Re: **PETITION NO. 1508 – Enfield Solar One, LLC and VCP, LLC d/b/a Verogy petition for a declaratory ruling, pursuant to Connecticut General Statutes §4-176 and §16-50k, for the proposed construction, maintenance and operation of a 4.0-megawatt AC solar photovoltaic electric generating facility located at 110 North Street, Enfield, Connecticut, and associated electrical interconnection.**

Proposed Facility Changes

PETITION NO. 1508 – ENFIELD SOLAR ONE, LLC

PROPOSED PROJECT CHANGES

SHEET TITLE:
 SITE & UTILITY PLAN

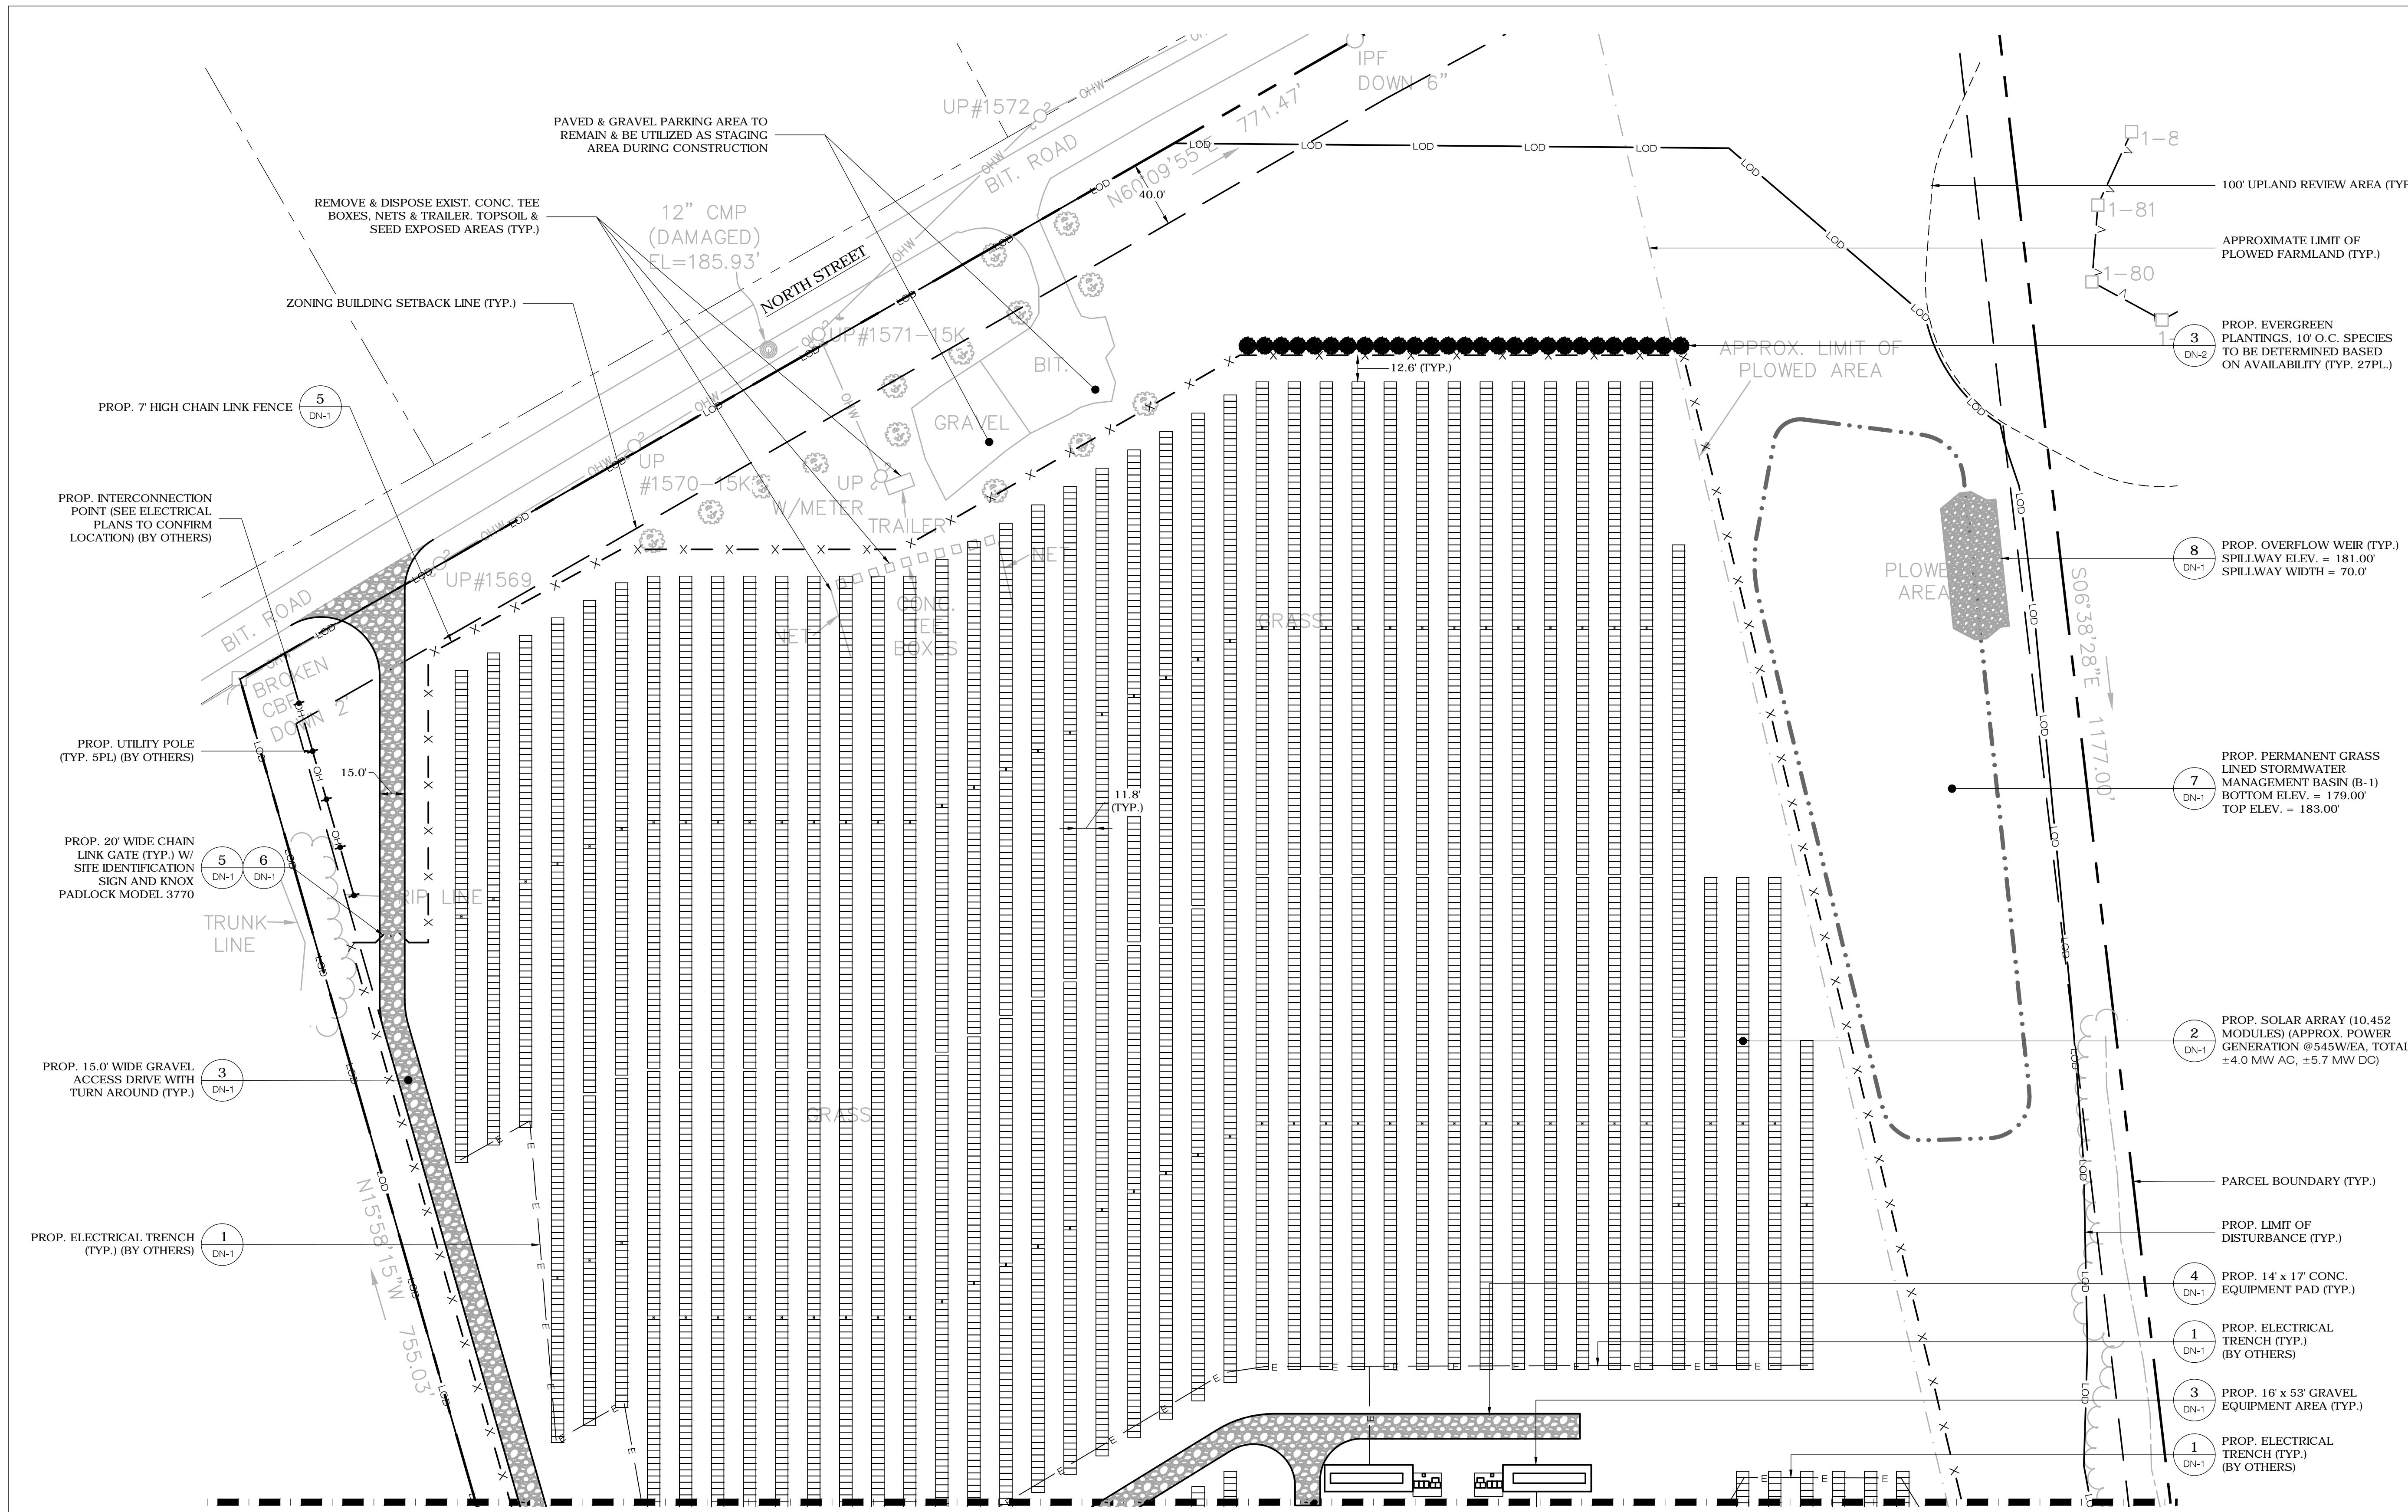
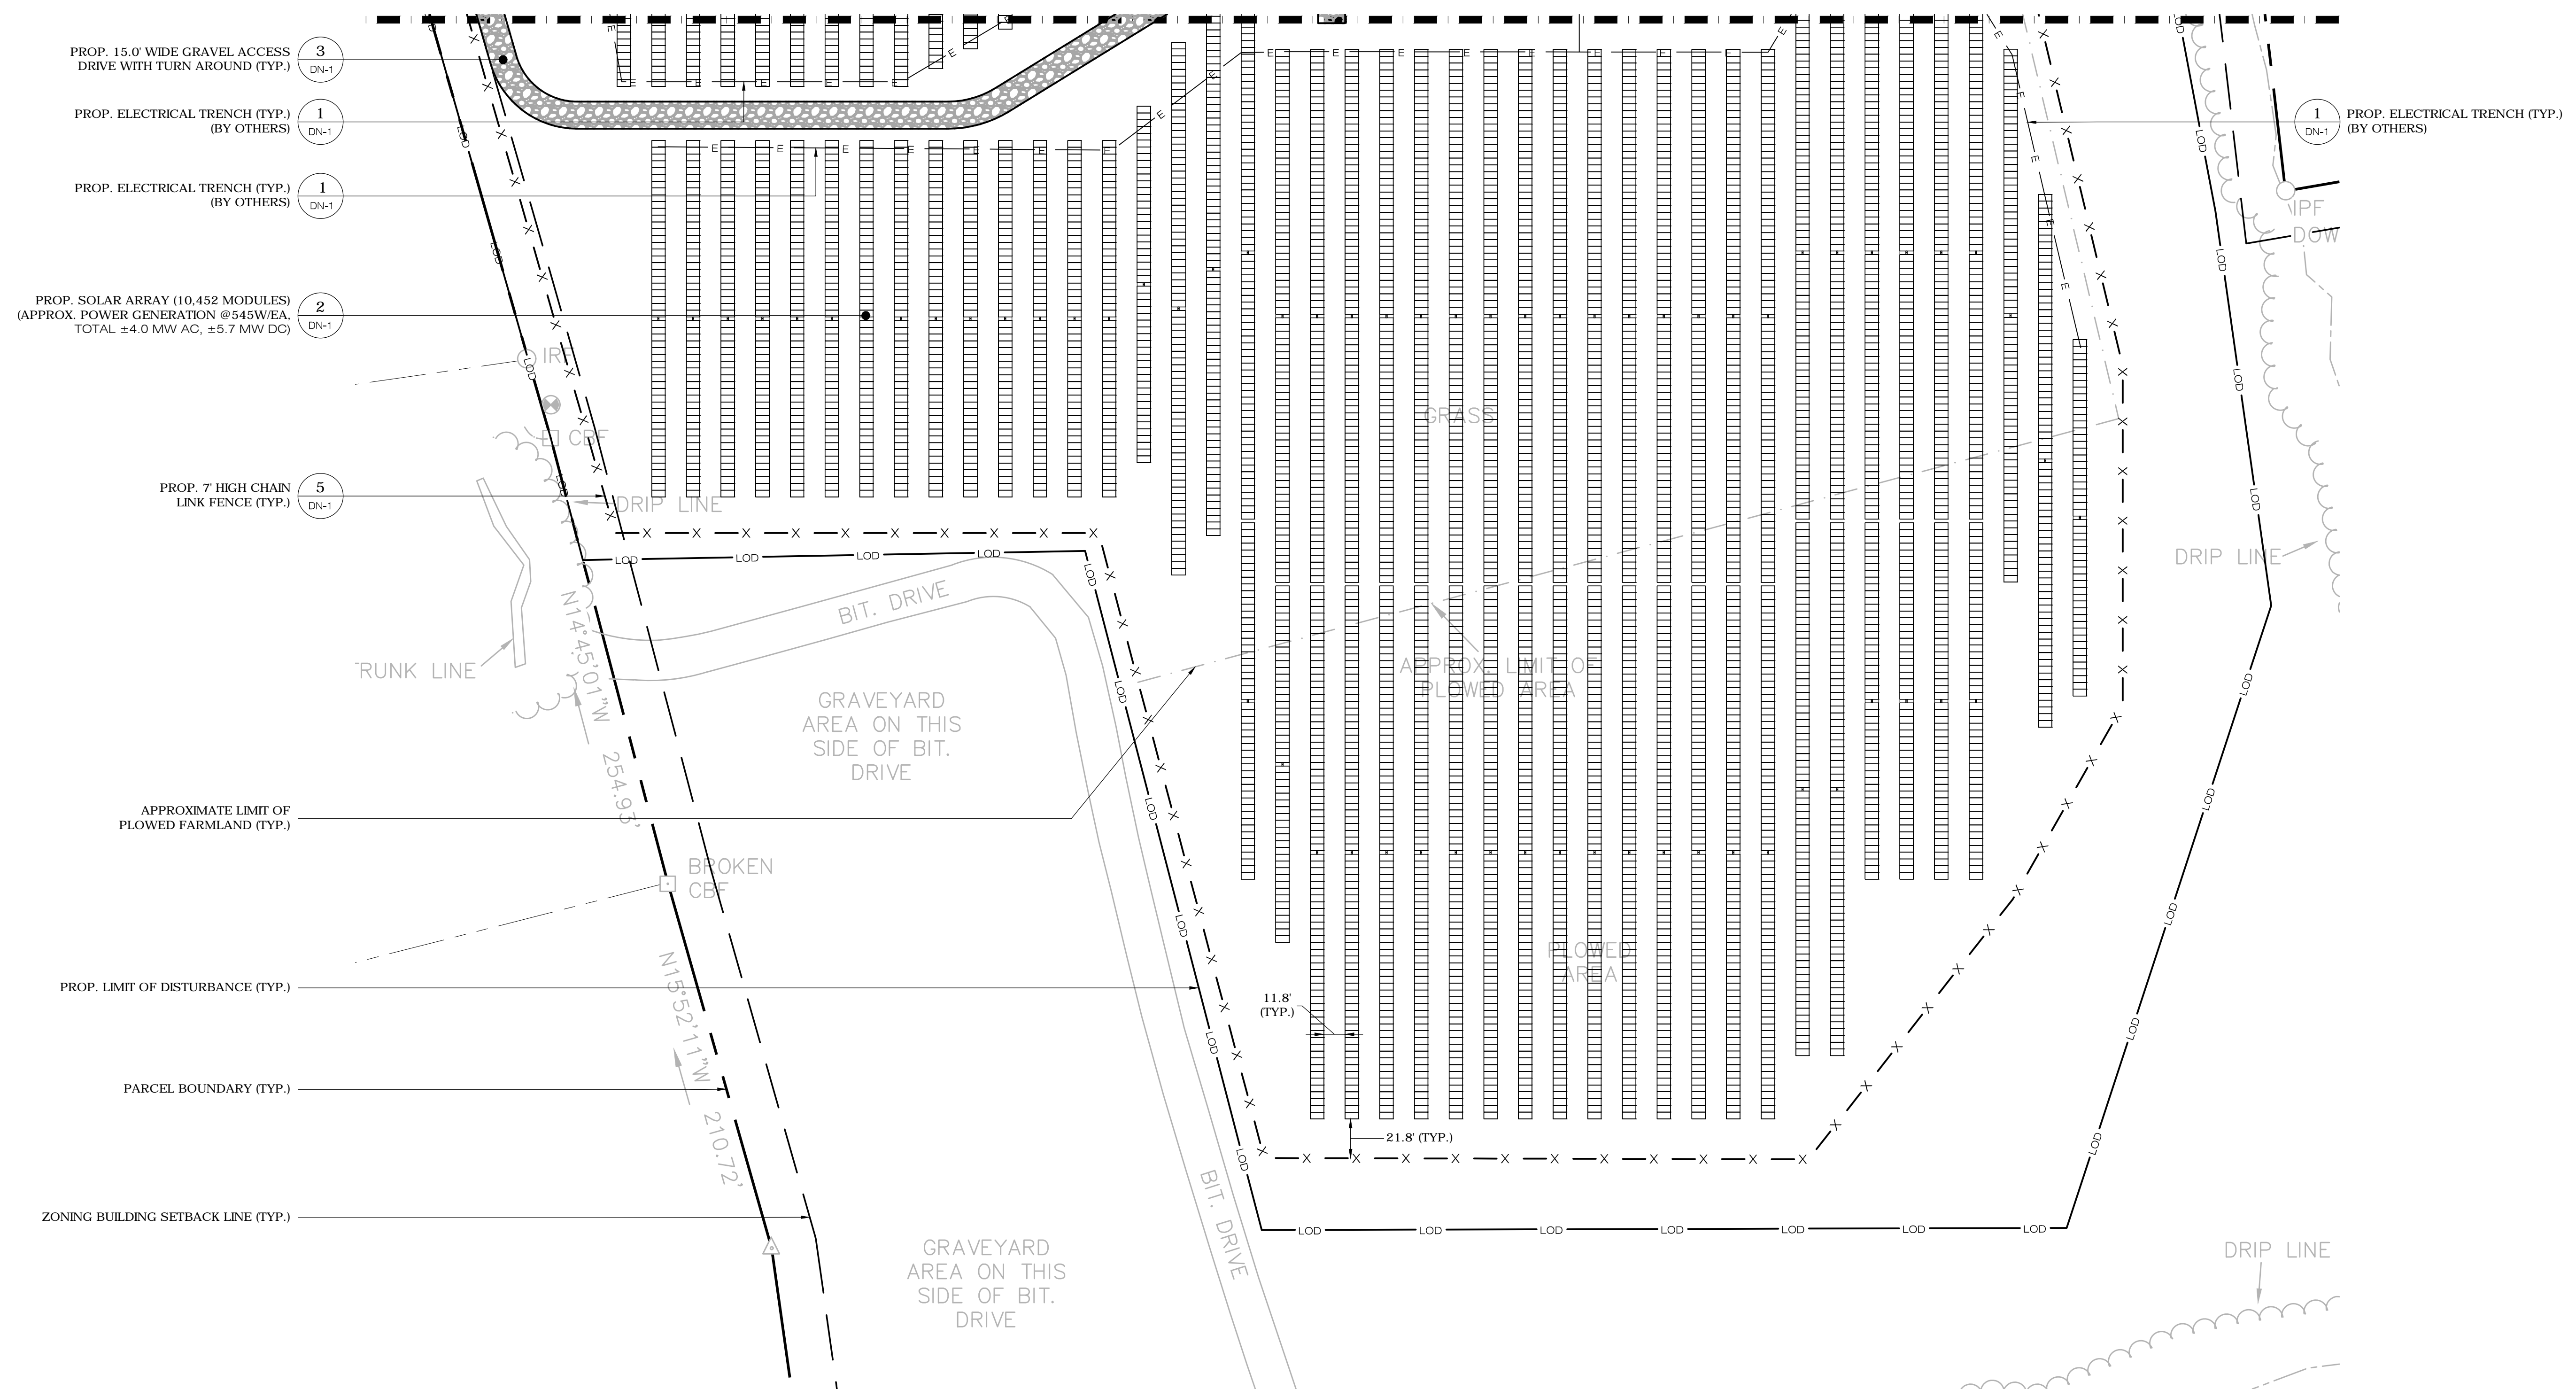
The proposed civil site drawings have also been revised to include additional landscape screening in the northeast corner of the Site as required by Condition No. 4 of the Council’s approval.

2 TYPICAL TRACKER POST MOUNTED RACKING SYSTEM
DN-1 SCALE : N.T.S.

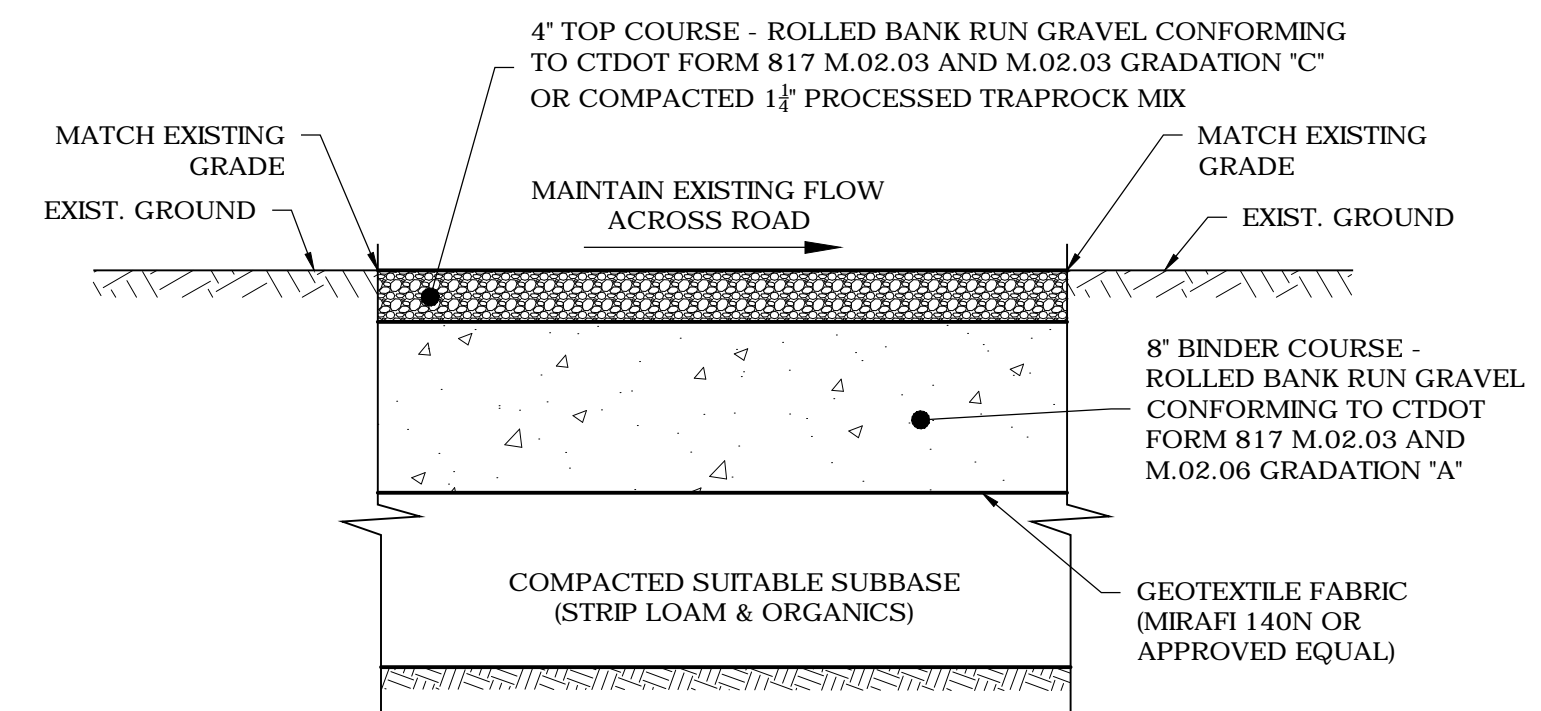
The Facility is proposing to use Solar Flex Rack’s FlexTrack – S Series trackers. The trackers are single-axis in the north-south direction and will have 1 module in portrait orientation along the axis. The tracker will have a maximum tilt in the east /west direction of 55 degrees with the lower edge being approximately 24 inches above grade. The upper edge of the panel will be approximately 8.25 feet above grade. See Attachment C for tracker specification sheet.
